CHELTONHAM DRIVE BIKEWAY

MANDATORY REFERRAL NO. MR2026005

COMPLETED: 12/4/2025

PLANNING BOARD HEARING DATE: 12/11/2025

Figure 4: Typical Section - Norfolk Avenue

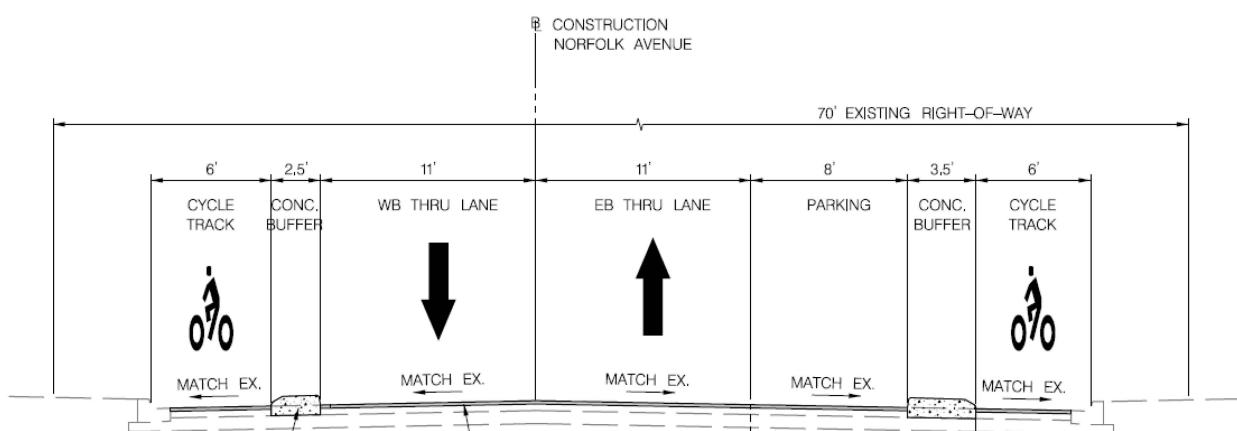
Comment: Narrow travel lanes from 11 feet to 10.5 feet and use the recovered space to expand street buffers, consistent with the *Complete Streets Design Guide*.

As shown in Tables 1 and 2, travel lanes along Downtown Streets should be 10.5 feet wide. Travel lanes in the proposed design are 11 feet wide. On the block of Norfolk Avenue between Woodmont Avenue and Wisconsin Avenue, narrowing these lanes by half a foot will allow the westbound street buffer to expand from 2.5 feet to 3.5 feet. This wider buffer still does not achieve the default buffer width for the street type, but provides greater separation from motor vehicles than what is currently designed. On the block of Cheltenham Drive between Wisconsin Avenue and Tilbury Street, similarly narrowing the lanes will allow the street buffers in both directions to expand from 2 feet to 2.5 feet, providing greater separation from motor vehicles than what is currently designed.

Figure 19: Cheltenham Drive/Wisconsin Avenue Intersection – Mandatory Referral Design

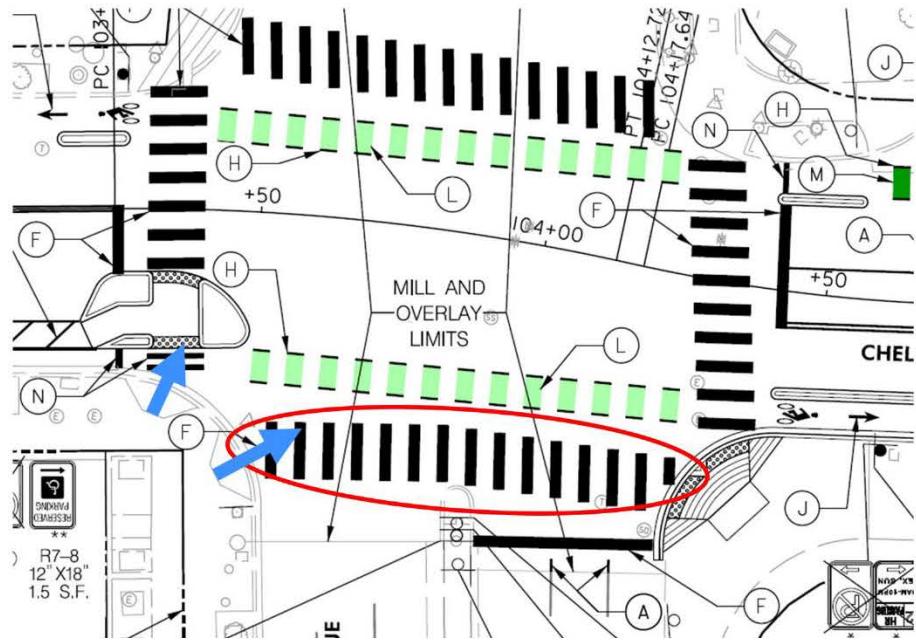
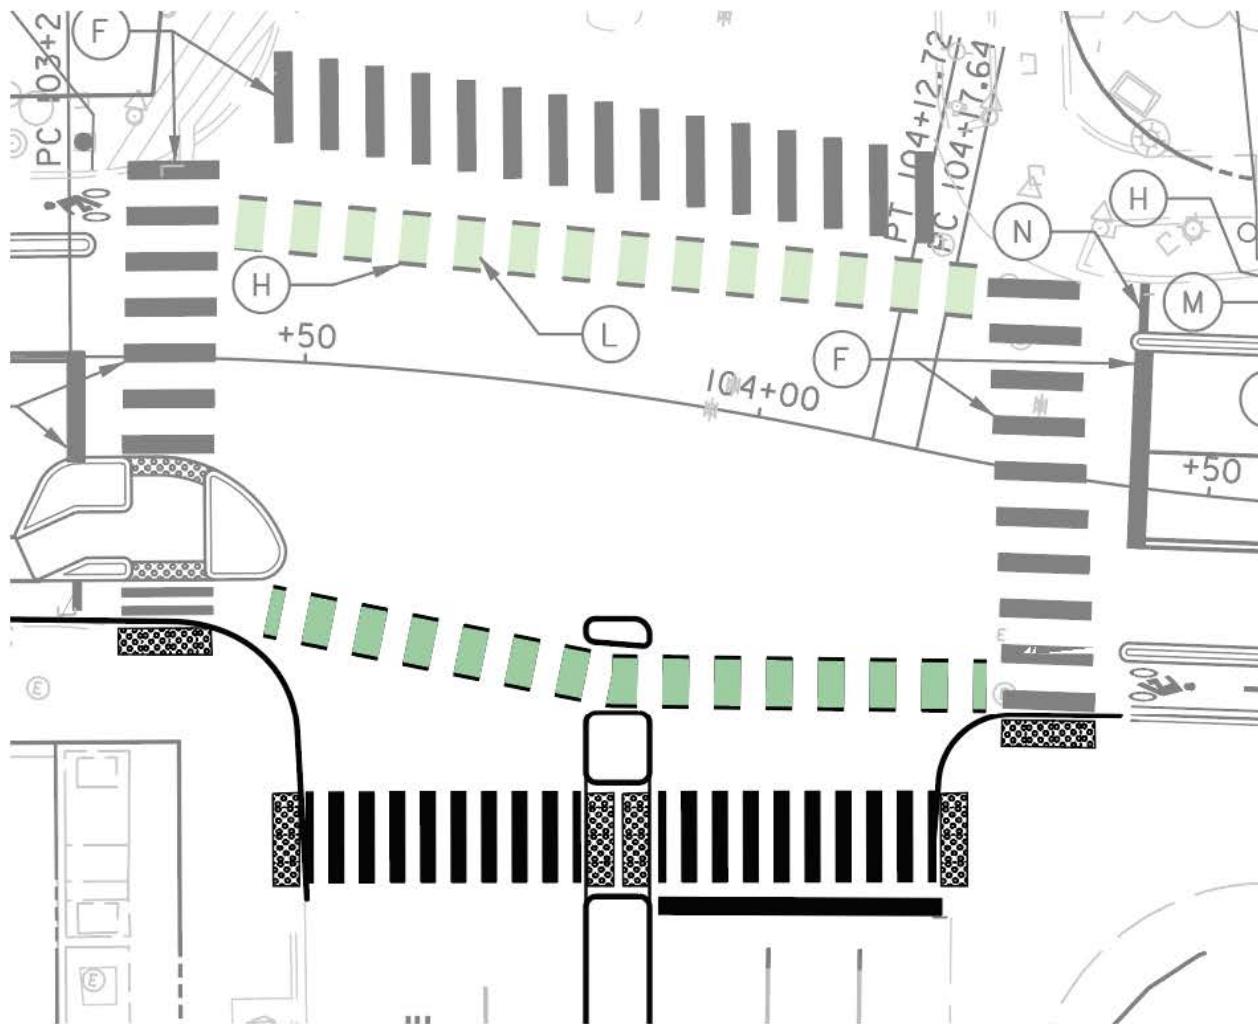
Comment: At the Cheltenham Drive intersection with Wisconsin Avenue, set back the southern pedestrian crosswalk farther from the intersection and tighten curb radii in line with *Complete Streets Design Guide* defaults to improve safety and accessibility.

As shown in Figure 19 in red, the southern crosswalk does not go straight across Wisconsin Avenue. Instead, it has a slight kink at the nose of the median separating north- and southbound traffic. This jog reduces the value of the marked crosswalk to people with vision disabilities because it requires maneuvering in the street, rather than just continuing straight.

Additionally, the proposed curb ramps on the southwestern corner for both the western and southern crossings do not align with their respective receiving curb ramps. Instead, they guide pedestrians either into the middle of the street or into curbs, as shown with thick blue arrows in Figure 19.

Planning Staff developed Figure 20, which shifts the southern crosswalk and its curb ramps farther south. These changes would allow the crosswalk markings to be installed straight across Wisconsin Avenue and the curb ramps perpendicular to the street, providing more helpful guidance for pedestrians of all ages and abilities. The nose of the concrete median should also be extended to protect crossing pedestrians and bicyclists from turning motorists. The southwestern curb ramp for the western crossing leg could also be reconstructed to be perpendicular by building out the southwestern curb to have a much tighter radius. This is possible because the curb line that controls vehicular turning radii at this corner is designed to be farther out into the street as part of the bikeway construction.

Figure 22: MCDOT Proposed Westbound Shared Lane in front of Cheltenham Drive Urban Park

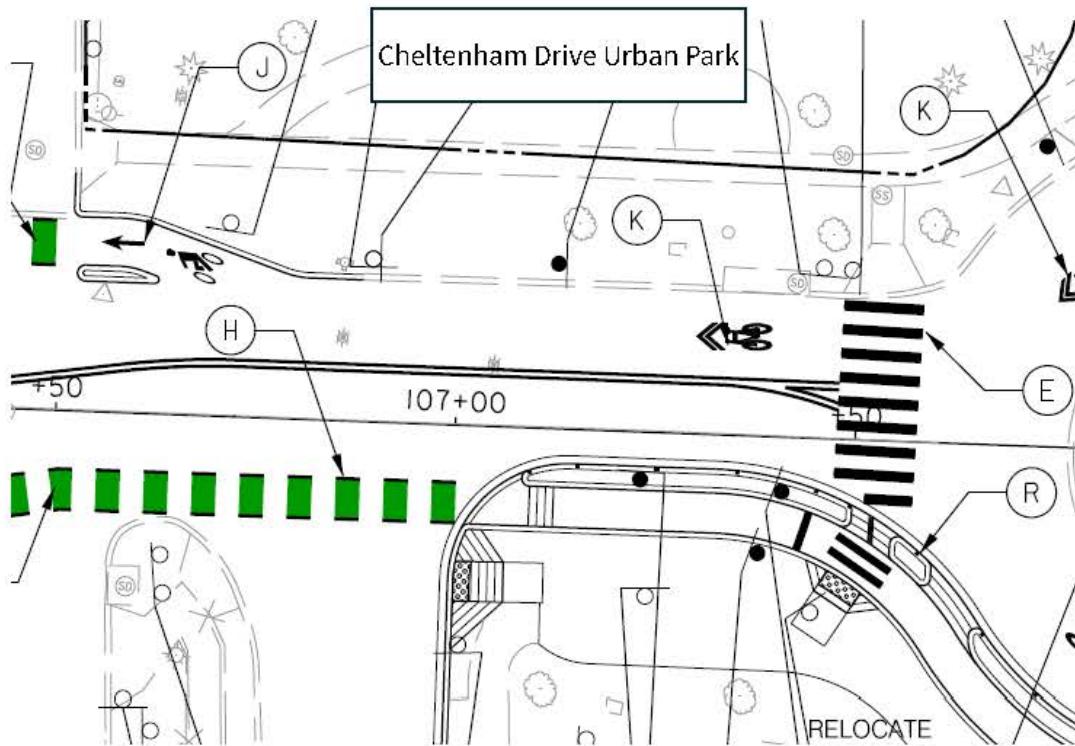
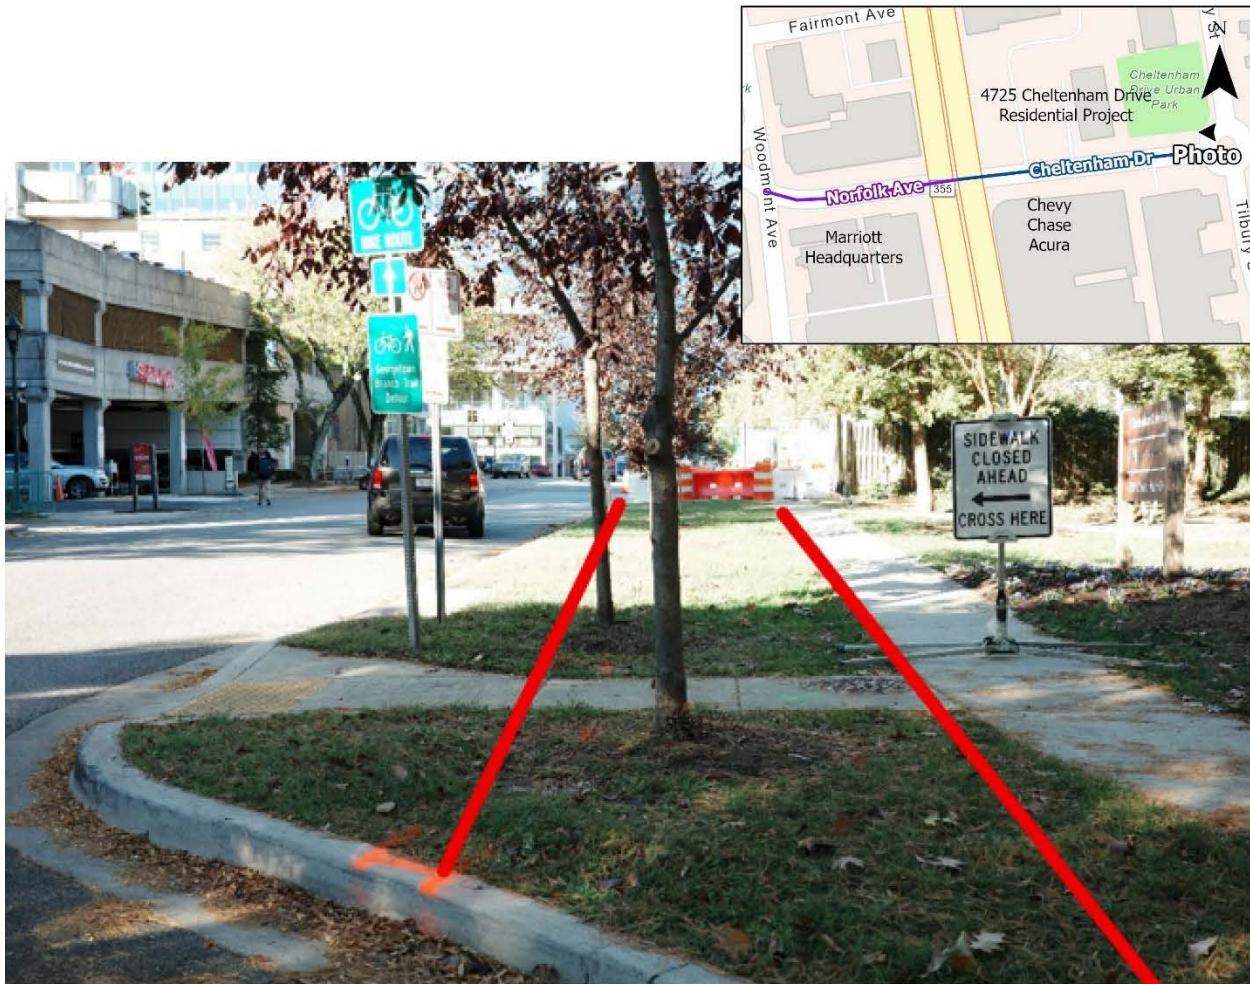
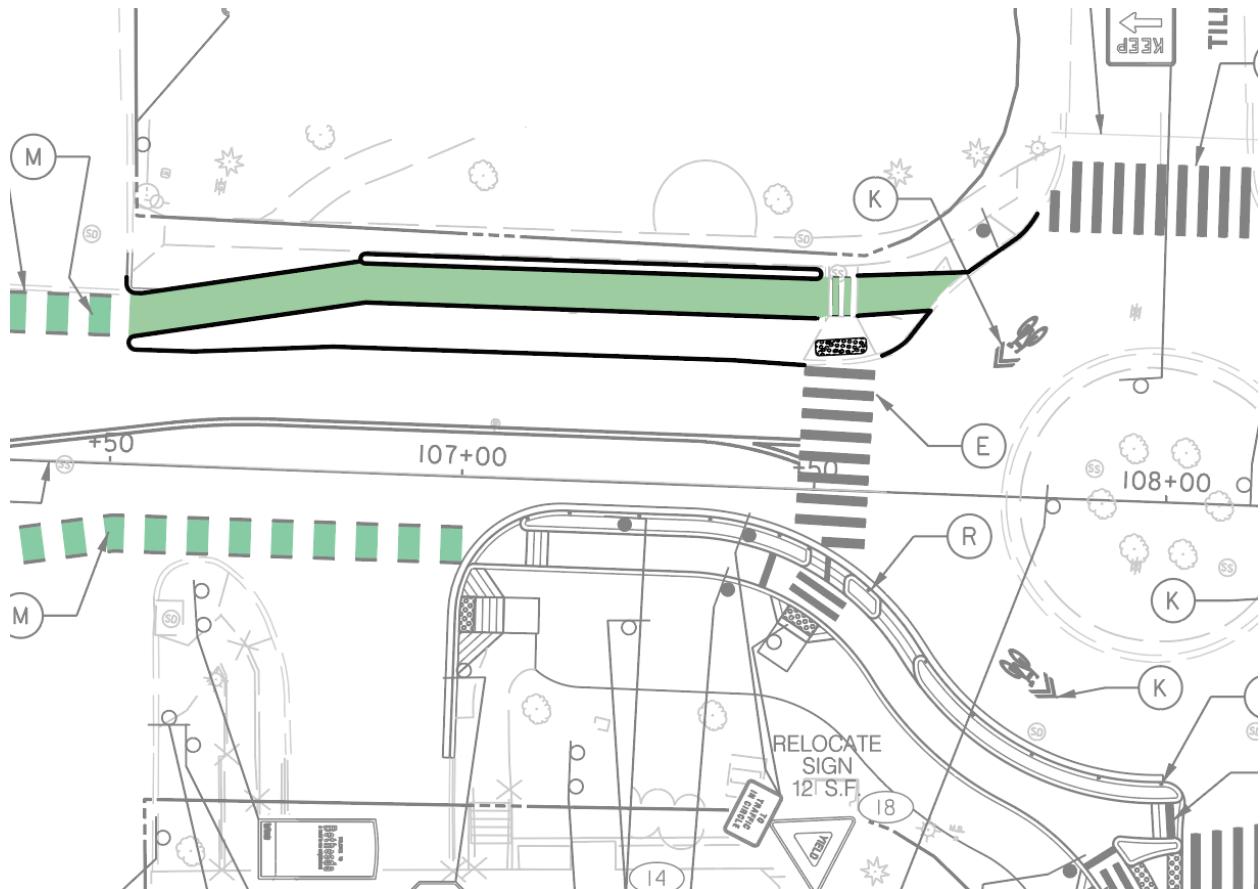
Figure 21 shows that there are currently High Stress and Low Stress segments in the project area. With the separated bike lanes proposed as part of this project, most of this corridor will be Very Low Stress, the best BLTS score. The exception is in the westbound direction in front of Cheltenham Drive Urban Park where the current design does not include a separated bike lane. Instead, bicyclists must exit the traffic circle in the motor vehicle lane and then merge into the separated bike lane at the alley, as shown in Figure 22. This is more stressful than bicycling in a separated bike lane, so this segment would be Low Stress (appropriate for adults), but not Very Low Stress (appropriate for children) like the rest of the corridor.

Comment: Construct a one-way separated bike lane in the westbound direction in front of Cheltenham Drive Urban Park that meets *Complete Streets Design Guide* default dimensions to reduce conflicts between bicyclists and motorists and improve Bicycle Level of Traffic Stress to Very Low Stress.

There appears to be sufficient space behind the curb in the landscape panel to construct a separated bike lane without disrupting the existing sidewalk that fronts Cheltenham Drive Urban Park (Figure 23 and Figure 24). Montgomery Parks property does not begin until the northern edge of sidewalk, and

Montgomery Parks staff support constructing the bikeway in the public right-of-way in front of this park.

Figure 25: MCDOT Proposed Woodmont Avenue / Norfolk Avenue Intersection

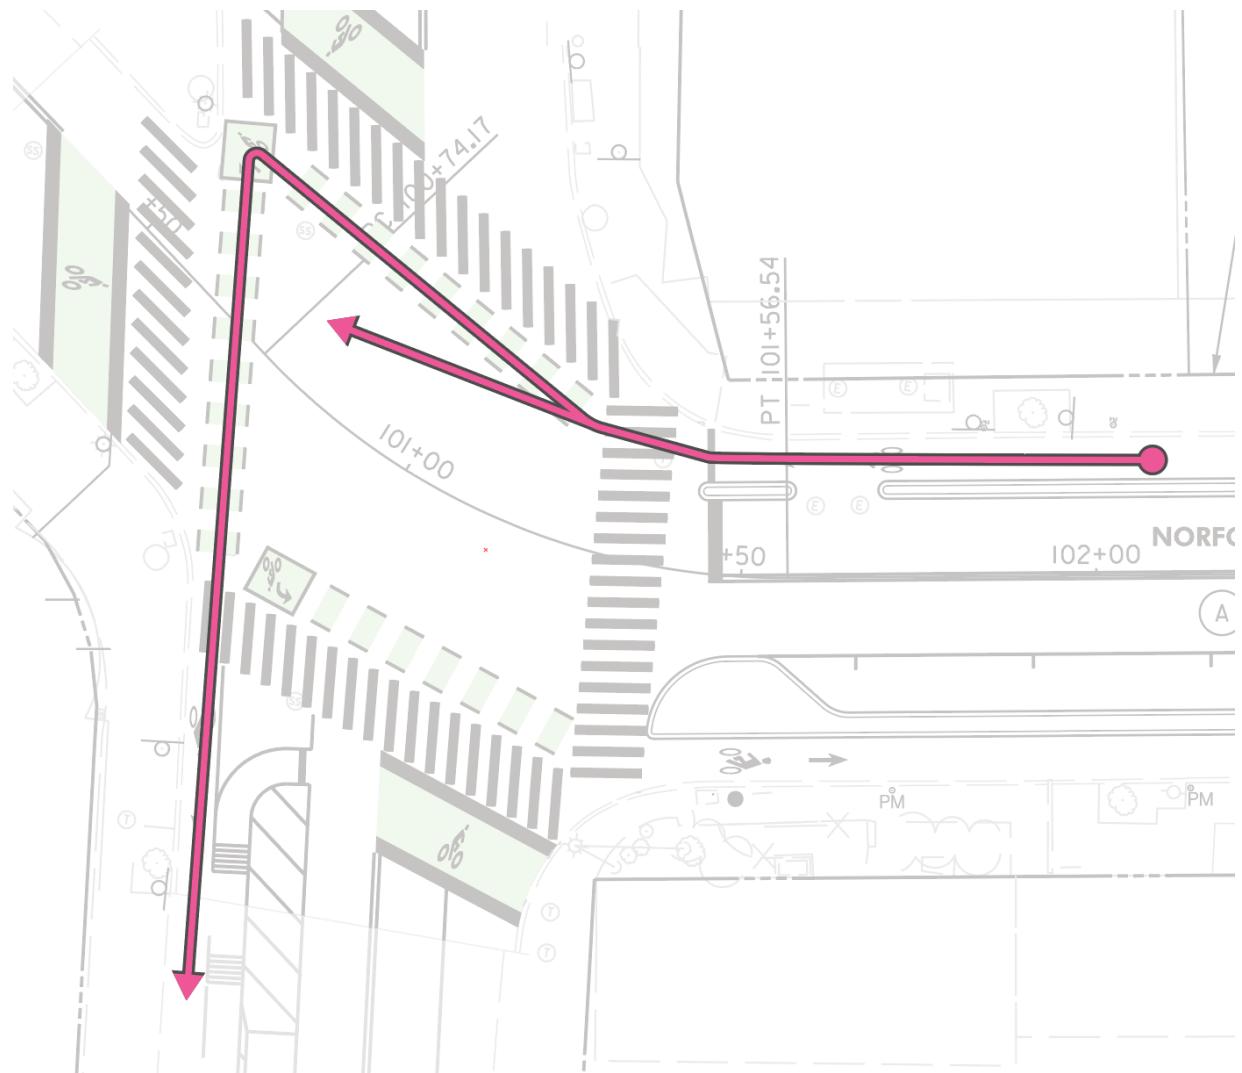
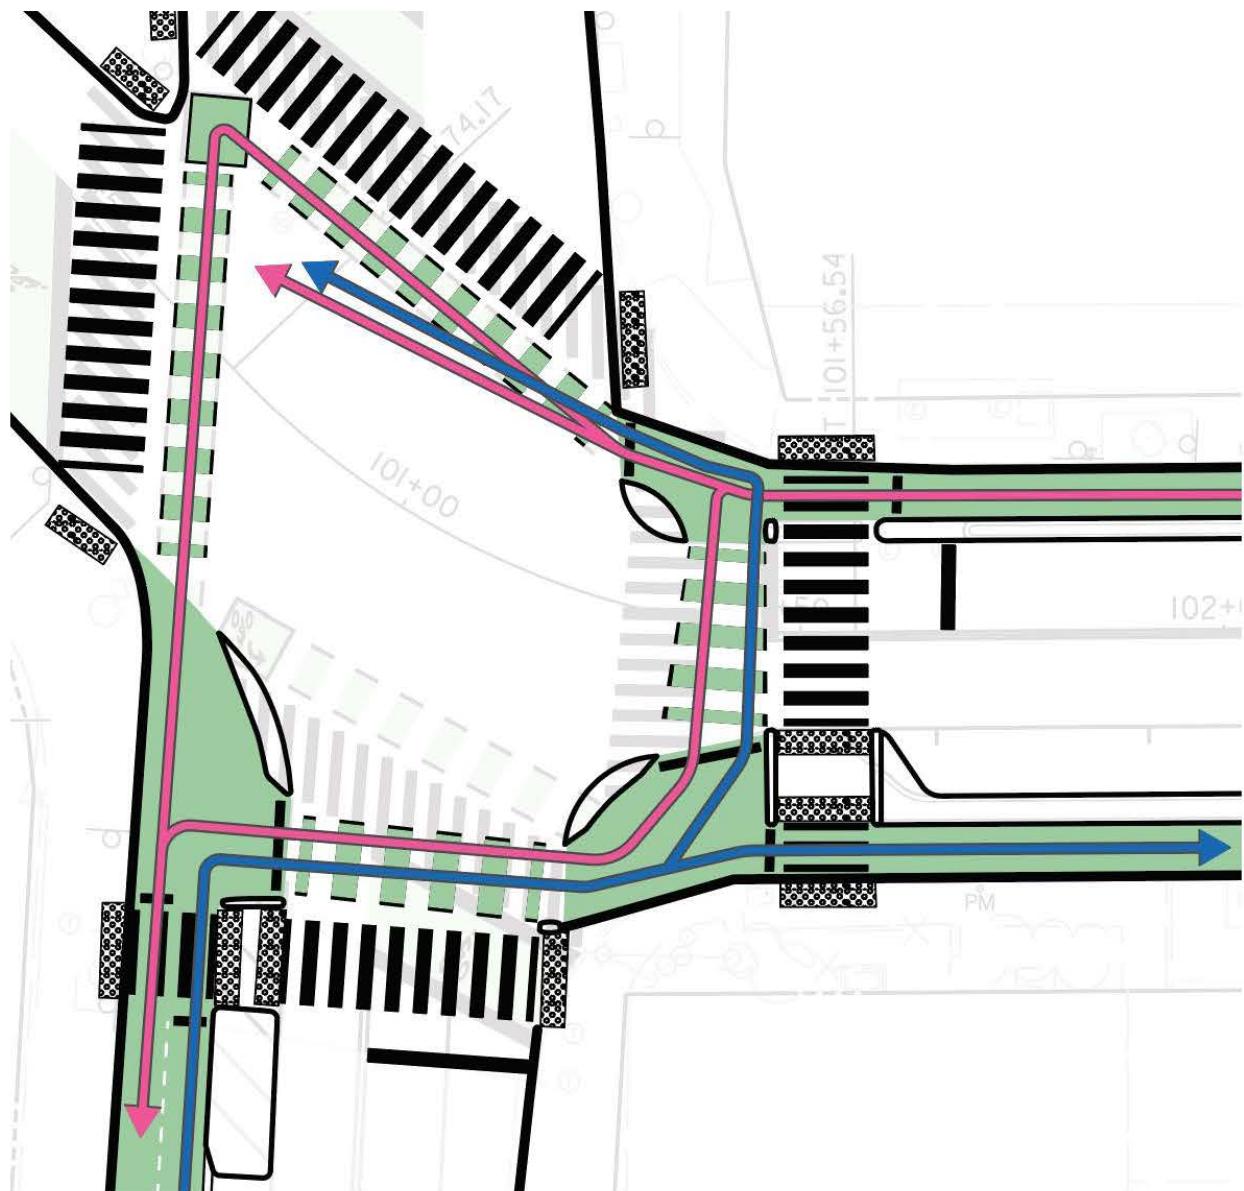
Comment: Redesign the intersection of Woodmont Avenue and Norfolk Avenue as a protected intersection.

As currently designed, the proposed bikeway effectively ends right before the Woodmont Avenue intersection. This creates several challenges (shown in Figure 25).

- 1) Bicyclists continuing westbound along Norfolk Avenue must merge into general traffic through the intersection, creating conflict and stress.
- 2) If arriving on a red signal, westbound bicyclists turning southbound into the Woodmont Avenue separated bike lanes must wait through a full signal cycle in two different locations to navigate through the intersection. First, they must wait for a green signal to cross to the bicycle box in the northwest corner of the intersection. Then, they must wait in that bicycle box through a full signal cycle for a green signal before proceeding south into the Woodmont Avenue bike lanes. This creates tremendous delay for bicyclists traveling through the area.

If a protected intersection is constructed with space gained from setting back the southern and eastern pedestrian crossings from the intersection (Figure 26), several opportunities emerge:

- 1) Corner islands can be constructed at the southeast and southwest corners of the intersection, tightening the curb radii, improving visibility, and slowing the turning speed of motor vehicles.
- 2) Space is created to allow bicyclists to cross in both directions on the eastern and southern legs of the intersection. This provides additional routing options and allows bicyclists to advance on their journeys regardless of intersection signal status when they arrive.
- 3) Pedestrian curb ramps and crossings can be made more perpendicular. This shortens crossing distances, provides easier crossings for people with visual impairments, and with the addition of the corner islands, reduces the amount of time pedestrians are exposed to motor vehicle traffic, leading to fewer crashes.

Figure 27: Bikeway Conflict Point at Tilbury Street Roundabout

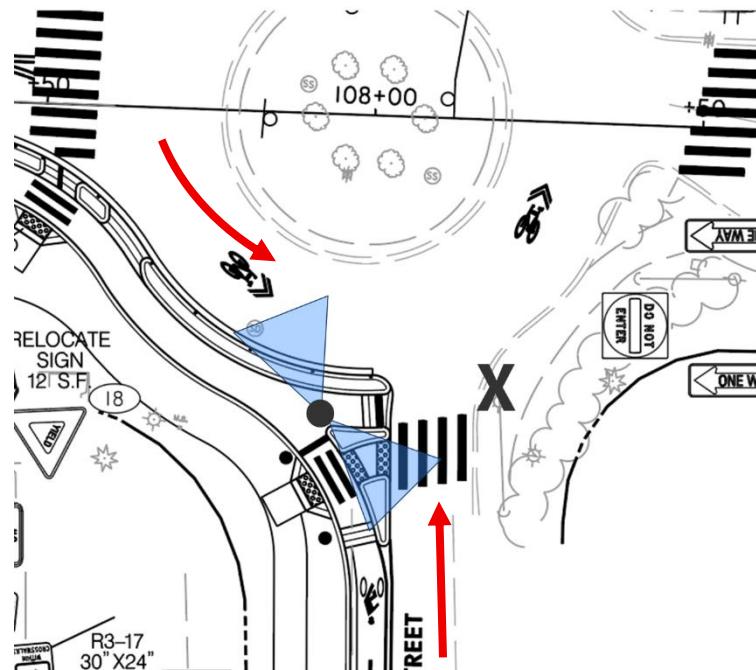
Comment: Ensure eastbound bicyclists entering the Tilbury Street roundabout can safely merge into the general travel lane where the separated bikeway ends.

safety reasons. In this project, the bikeway ends at a yield-controlled roundabout. This means that to safely enter the roundabout, bicyclists will have to look over their left shoulder to ensure there is a gap in traffic while at the same time looking to the right to determine if northbound Tilbury Street traffic will yield to them. The bicyclist fields of vision (the blue triangles) and potential conflicts (by the red arrows) are shown in Figure 27.

To reduce the likelihood of conflict, Staff recommends two changes:

- 1) **Raise the marked pedestrian crossing at the southern leg of the Tilbury Street roundabout to sidewalk level.**

This will act as a speed hump, slowing northbound motor vehicles on Tilbury Street approaching the roundabout and providing more time for bicyclists and motorists to see each other and for motorists to yield to traffic in the roundabout. Additionally, raised crossings (Figure 28) benefit pedestrians by reinforcing their priority to cross the street and allowing
